FRONTIER DEEPWATER APPRAISAL SOLUTIONS LLC
1118 DARIA DRIVE
HOUSTON, TX 77079
UNITED STATES

Subject: **ABS (Concept) Approval in Principle for:
Ultra-Deepwater Appraisal Production System (APS)**

[Figure 1: APS Concept](#)

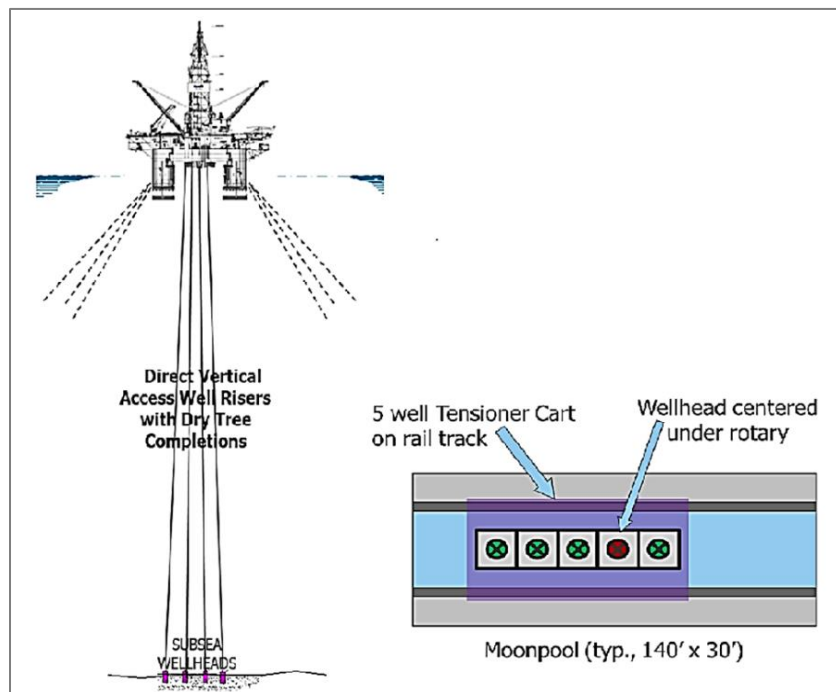
ABS review of the concept design (as shown in [figure 1](#)) is based on the submitted drawings and documents, and our current scope of work:

- Use of Moon pool Tensioner Cart philosophy to align wellheads beneath center of drilling derrick
- Tensioner Cart sliding and Locking Philosophy
- Impact of Tensioner Cart and well/riser tieback system loads on the MODU's deck and column structures, especially on Moon pool structure (Well Systems interface to MODU)
- Riser Design Philosophy (Riser Stretch and Slack)
- Impact of additional equipment added on MODU structure
- Use of Taut Leg Polyester Mooring System

the Frontier Deepwater APS Concept design provided following are addressed during subsequent stages of the technology maturation process:

1. ABS design requirements per following ABS Rules and Guide are addressed during subsequent design and engineering phases.
 - ABS 2012 (Updated Dec 2015) Guide for Classification of Drilling Systems (ABS CDS)
 - ABS Guidance Notes on Review and Approval of Novel Concepts (June 2003)
 - 2016 ABS Rules for Building and Classing Mobile Offshore Drilling Units (2016 MODU Rules)
 - ABS Rules for Building and Classing Offshore Installations
 - ABS 2015 Guidance Notes on Failure Mode and Effects Analysis (FMEA) for Classification
2. ABS Preliminary Review Observations and Comments as identified in Appendix B (Roadmap to Approval) are addressed during subsequent design and engineering phases.
3. Subsequent safety studies (i.e. HazID, HazOP, FMEA etc.) is performed.
